**SANTEE COMMUNITY CENTER
CIP 2018-31**

ADDENDUM NO. 5

This Addendum No. 5 (32 pages in total) forms an essential part of the contract documents by revising the following:

A1 1ST FLOOR - SEGMENT B - RCP
A3.11B 3/16" = 1'-0"

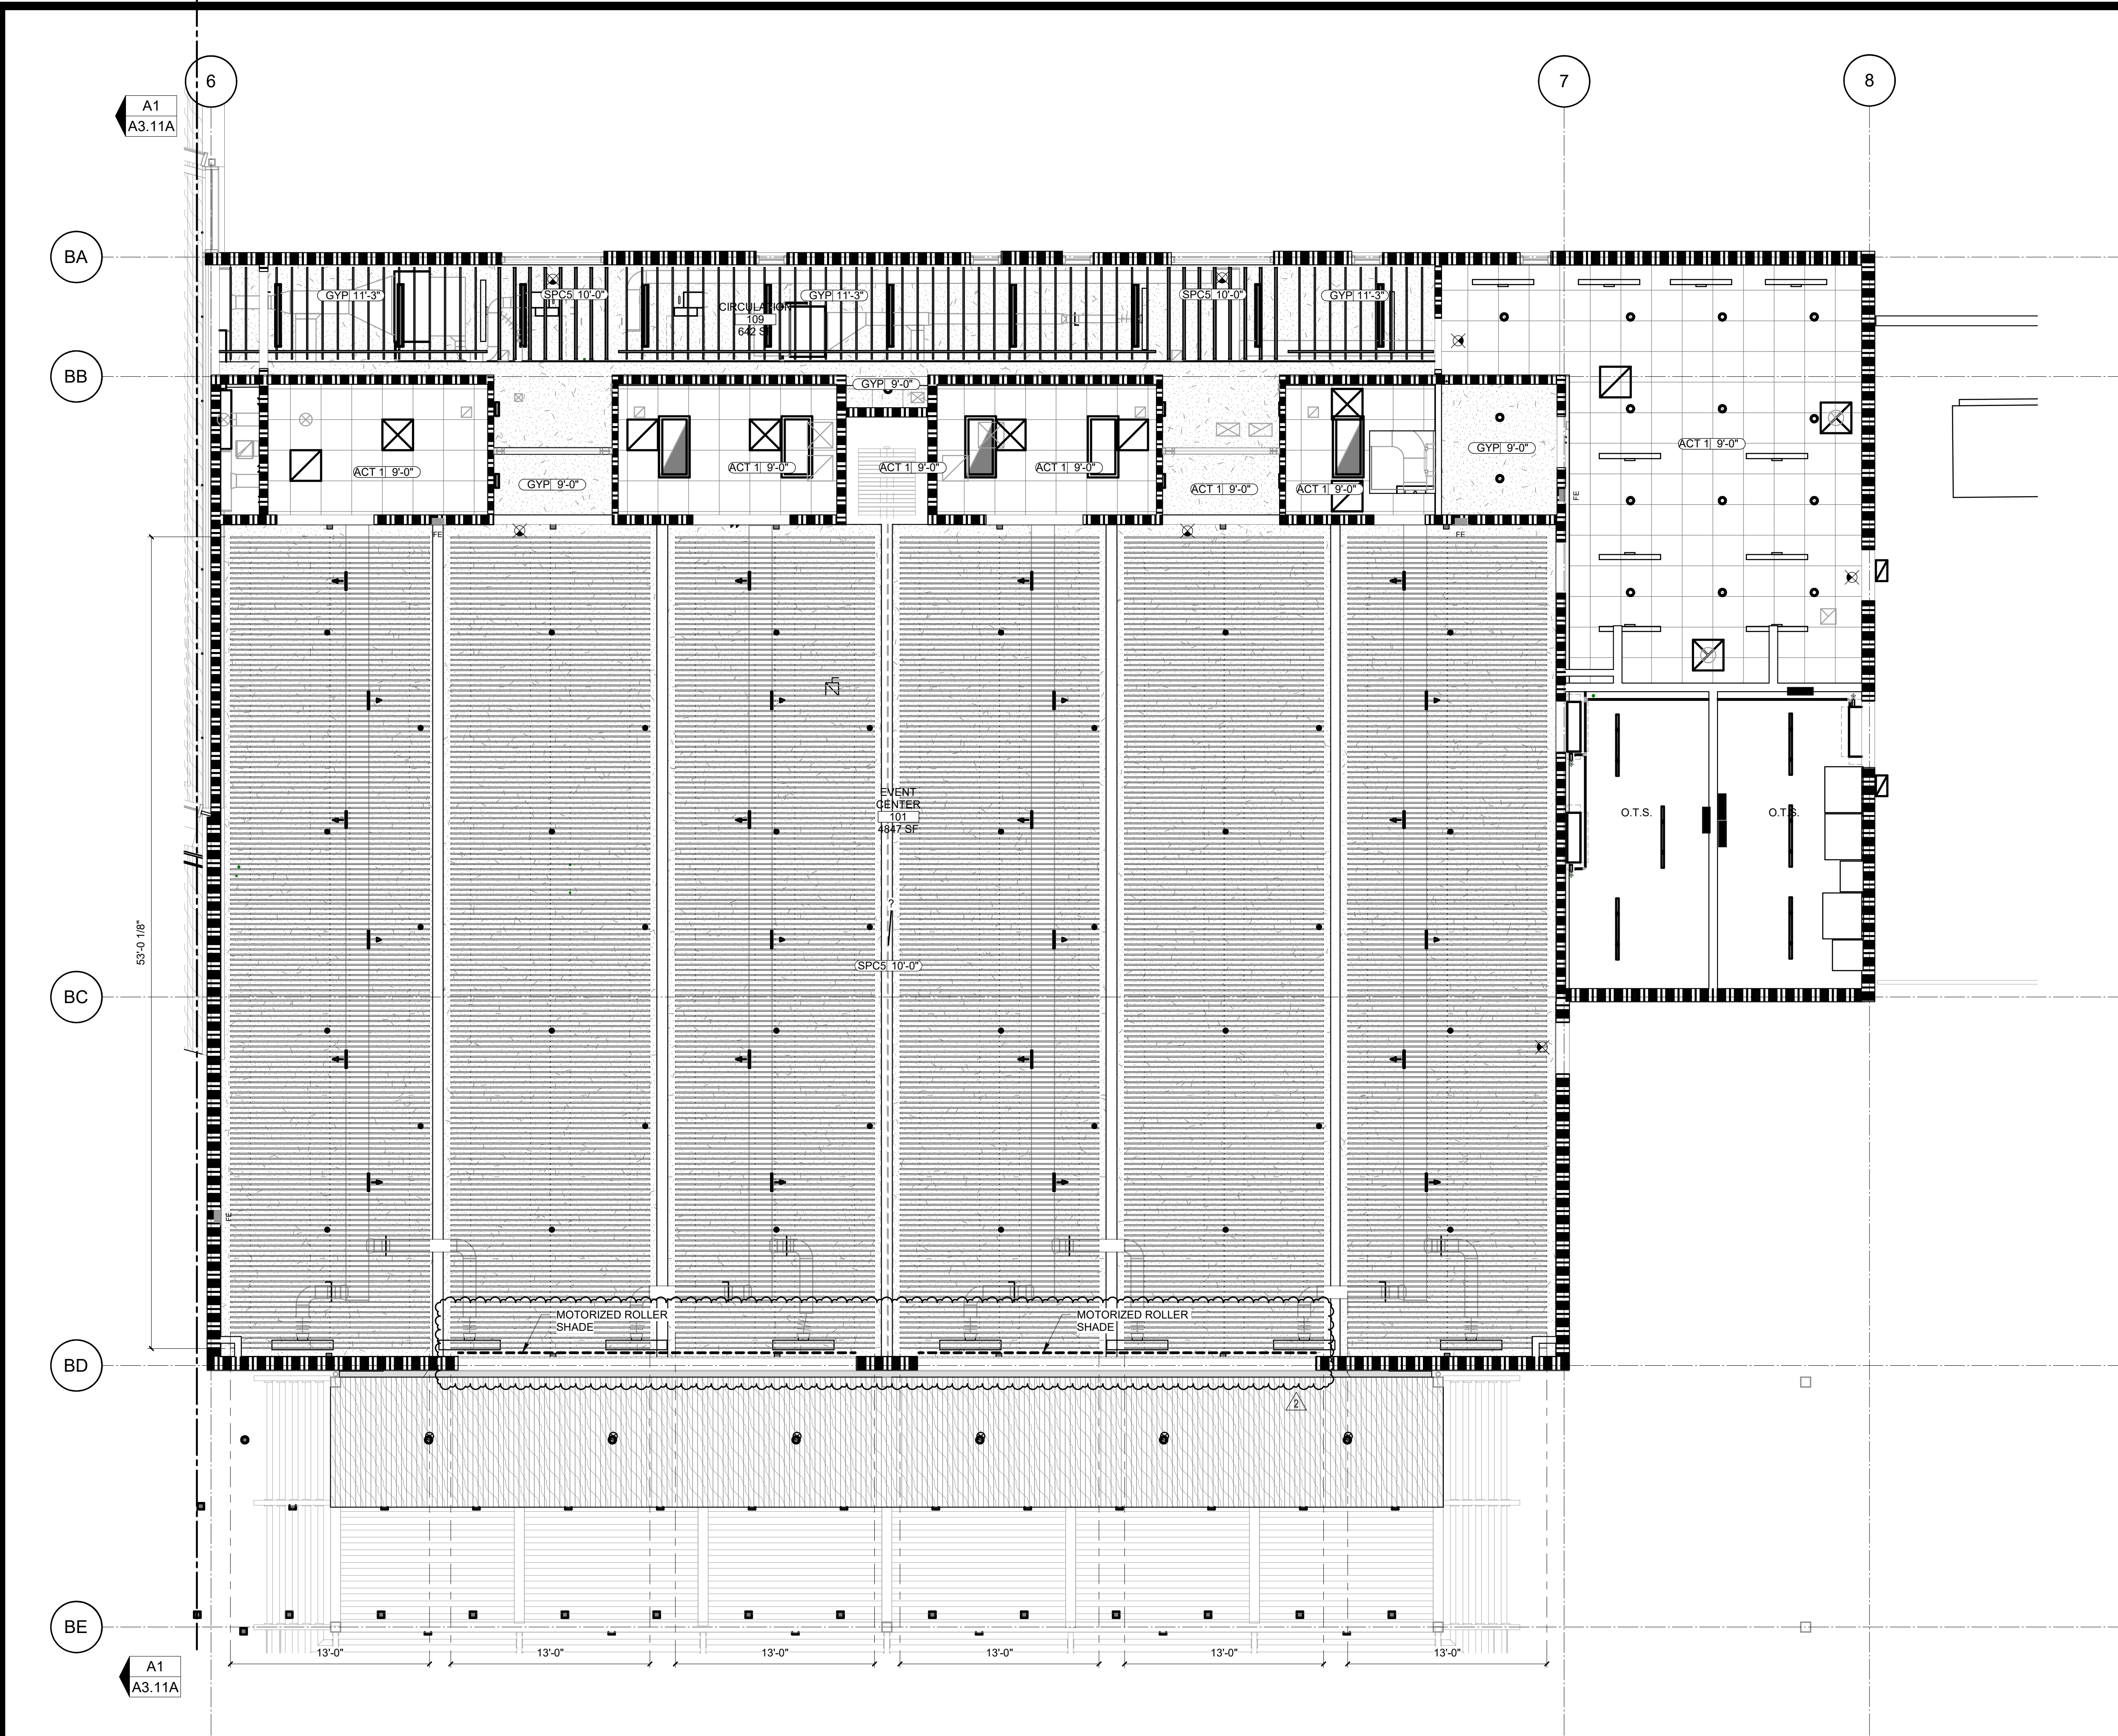
- 5C-4 Drawing Sheet **A3.11B - 1ST FLOOR - SEGMENT B - REFLECTED CEILING PLAN**
- For clarity, added callouts for motorized roller shades over openings 101A & 101B.

5D-16 Question: There is a spec for window coverings, roller shades (Spec 12 24 13). Page A9.22 shows RS-1 is for Shades. However there are no markings on the floor plans, or RCP plans etc. for RS-1 Shades.

Response: Refer to revised RCP sheets issued as part of this addendum.

4 ELEVATION - EXTERIOR - NORTH
3/32" = 1'-0"

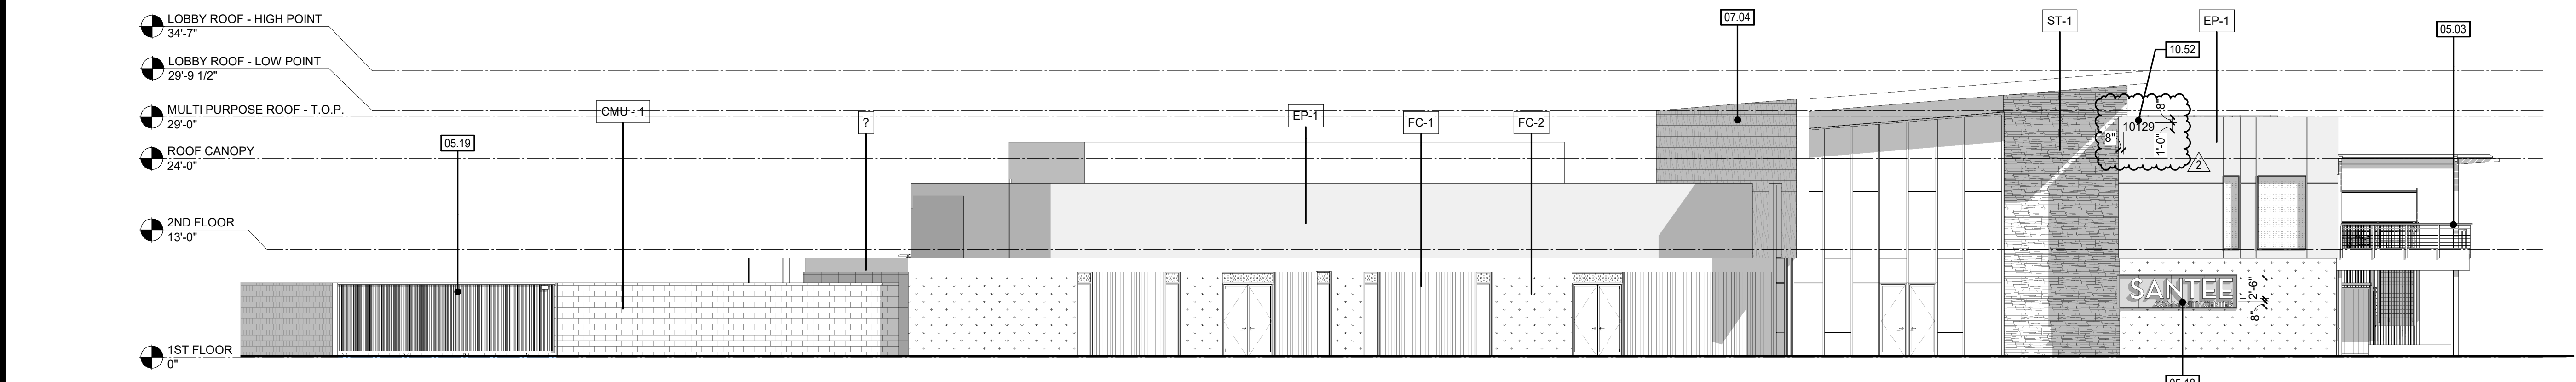
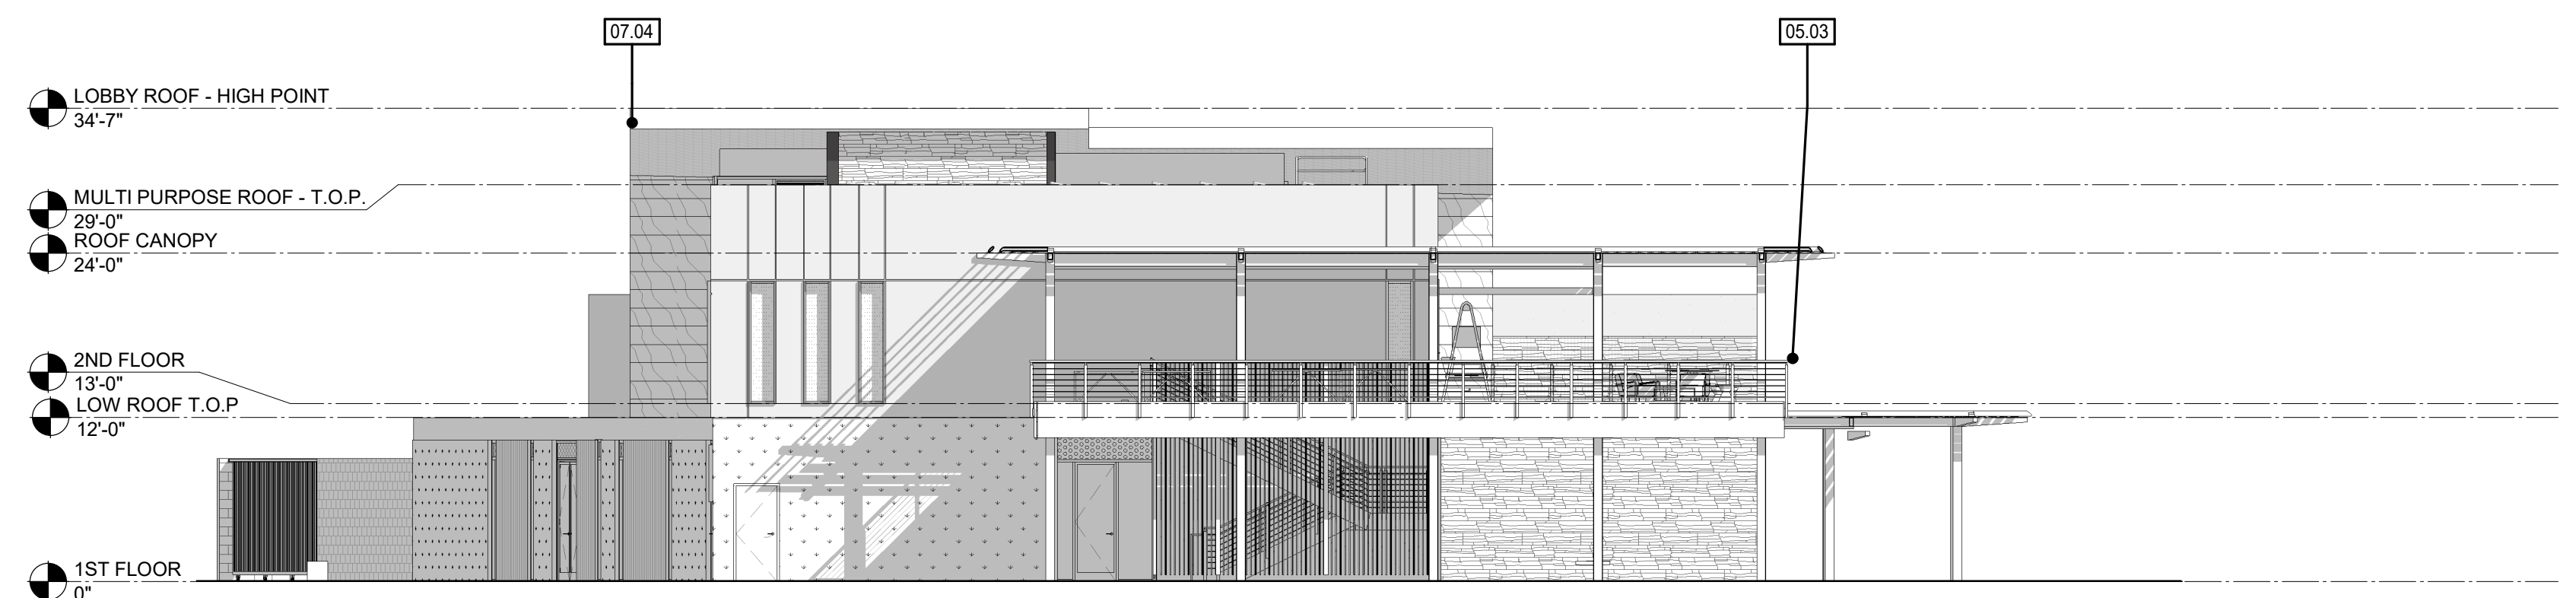
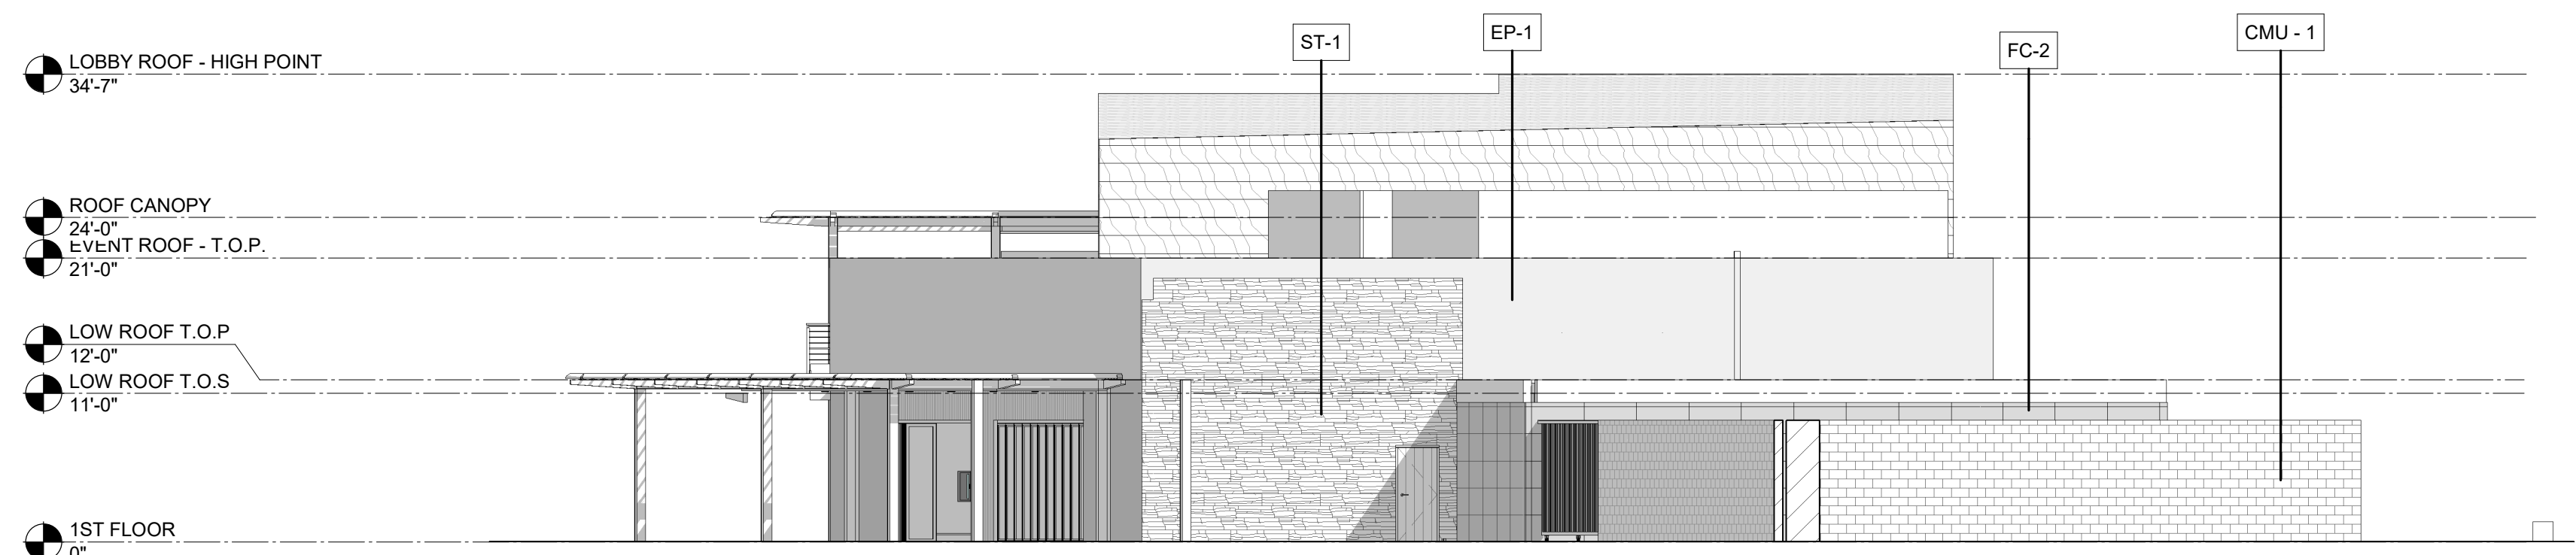
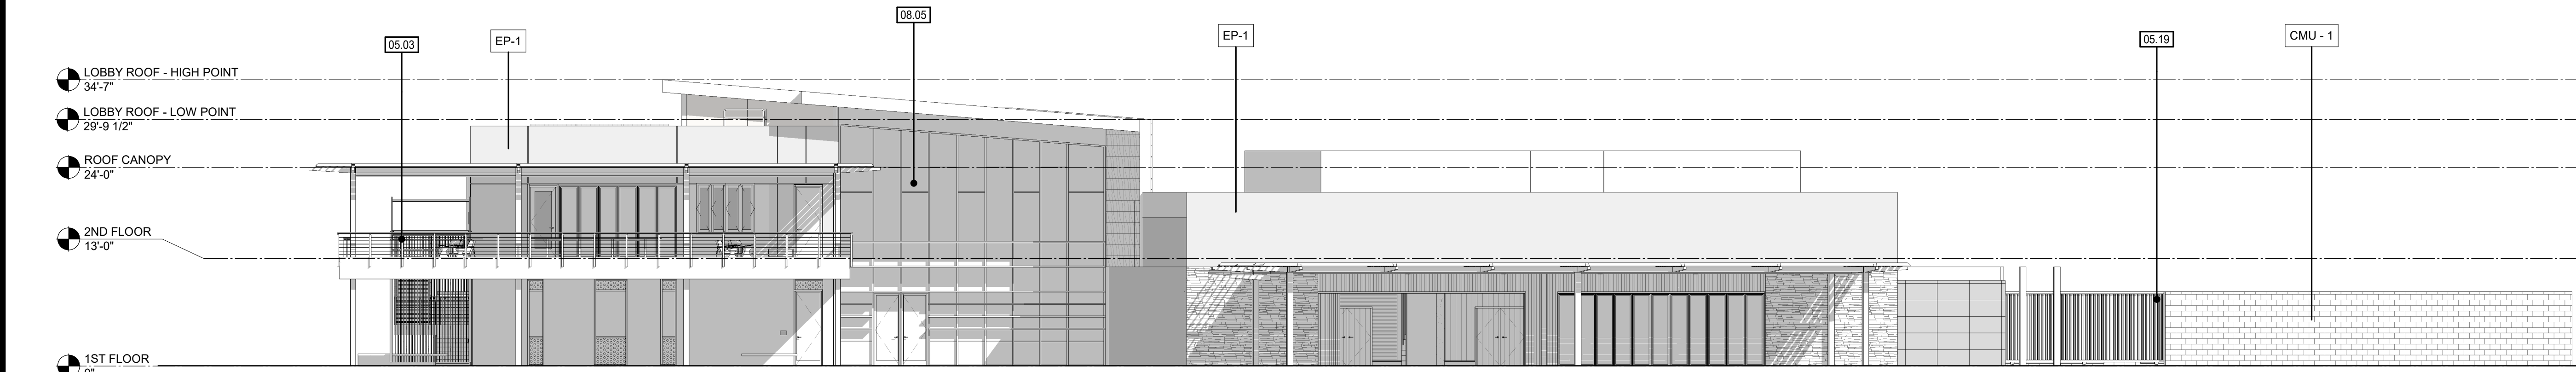
- 5C-5 Drawing Sheet **A5.11 - EXTERIOR ELEVATIONS - OVERALL**
- For clarity, revised keynote 10.52 and added dimensions to 4/A5.11.
- 5C-6 Drawing Sheet **A8.13 - 1ST FLOOR - INTERIOR ELEVATIONS**

5D-14 Question: Please provide a full detail to build the Building Address Numbers, Sheet A5.11 – 10.52 Address numbers placed near the roofline, numbers shall be block style, 12” in height, black in color. What is the full detail how to manufacture the Building Address Numbers (10.52)?

Response: Refer to revised keynote clarifying building address numbers on sheet A5.11 issued as part of this addendum.

3 EVENT CENTER - SOUTH
A8.13 1/4" = 1'-0"

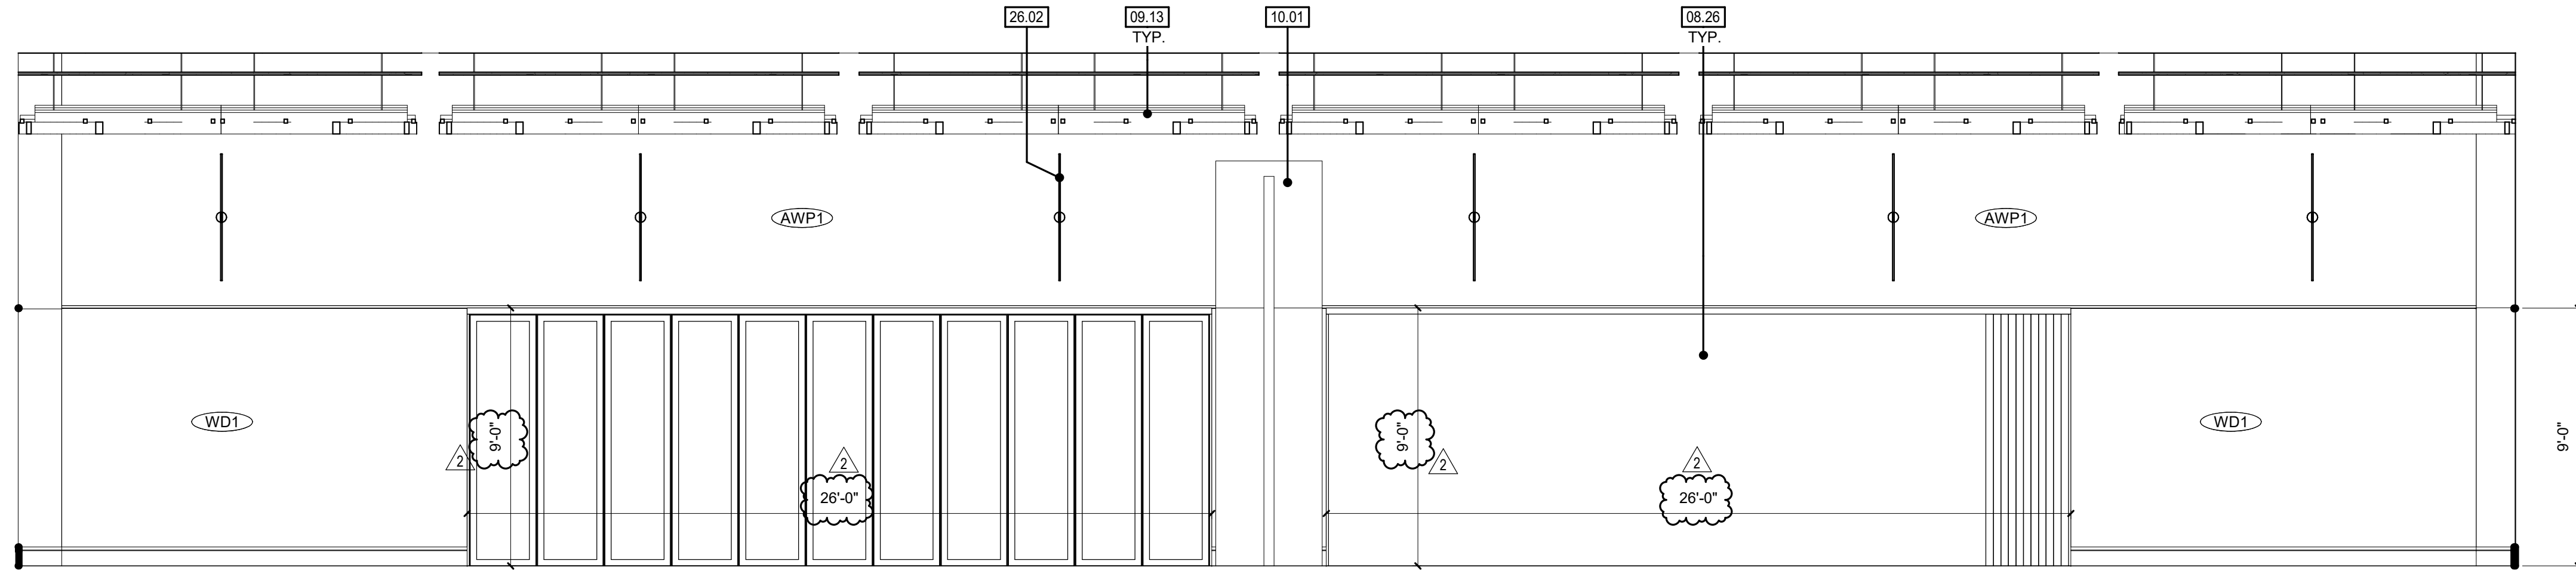
- For clarity, added dimensions to openings 101A & 101B in elevation 3/A8.13.
- 5C-7 Drawing Sheet **A9.11 – DOOR SCHEDULE**
- Revised door hardware set callouts.
